## **RAPIER AVENUE SUBDIVISION**

APPLICATION NUMBER 4 DATE December 2, 2021  
APPLICANT Rapier Avenue Subdivision  
REQUEST Subdivision

# DETAIL SITE PLAN

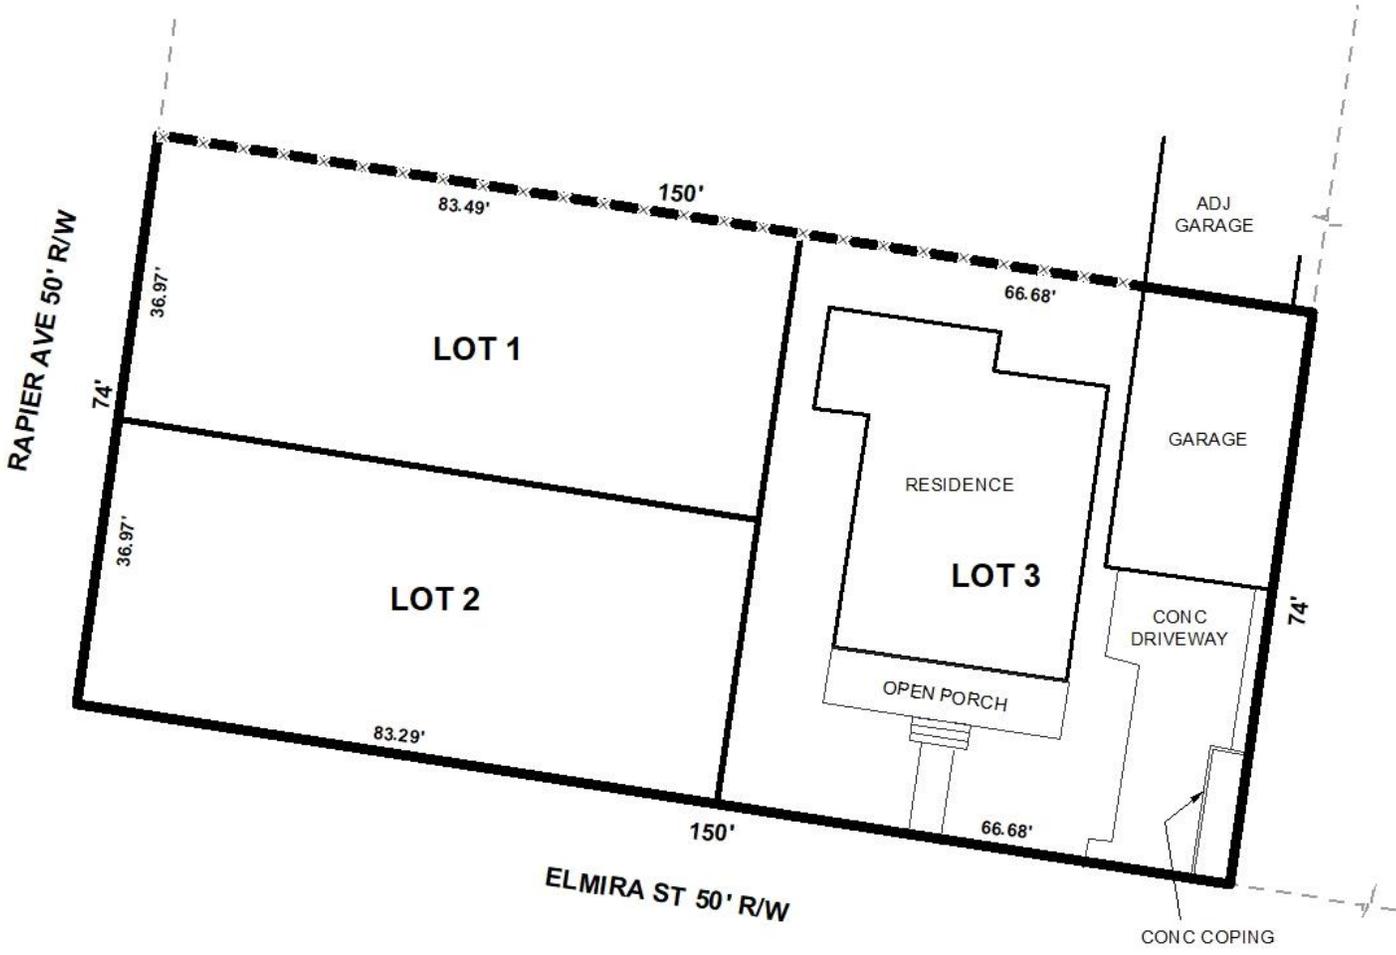
- B. Review and revise the last distance call-out on the south boundary of the proposed subdivision.
- C. Provide the Surveyor's and Owner's (notarized) signatures.

Furthermore, the proposed subdivision will result in Lots 1 and 2 having 36.97 feet of frontage along Rapier Avenue, and proposed Lot 3 having 66.68 feet of frontage along Elmira Street. Lot 1 would have 3,091 square feet; Lot 2 would have 3,081 square feet; and Lot 3 would have 4,946 square feet. Lots 1 and 2 would not meet the minimum width requirement (60-foot width at the building setback line), and none of the three would meet the minimum area requirement of 7,200 square feet of Section V.D.2. of the Subdivision Regulations. Given that the site is in the Oakleigh Garden Historic District, substandard size lots are common, and the Commission has approved other small-lot subdivisions within the area. However, those subdivisions were in instances where dwellings already existed on the proposed lots, and the subdivisions were intended to provide a separate lot of record for an existing dwelling, even though the lots were of substandard size. In this instance, the lot size for the existing dwelling would be reduced from a compliant size to a noncompliant size, and all three proposed lots would be of substandard size and would be in violation of both the Zoning Ordinance and Subdivision Regulations.

- 1) the applicant has not provided proof of ownership for the subject property, nor has authorization for the application submission from the current owner of record been provided; and
- 2) the subdivision would create substandard size lots which would be in violation of the Subdivision Regulations and Zoning Ordinance.
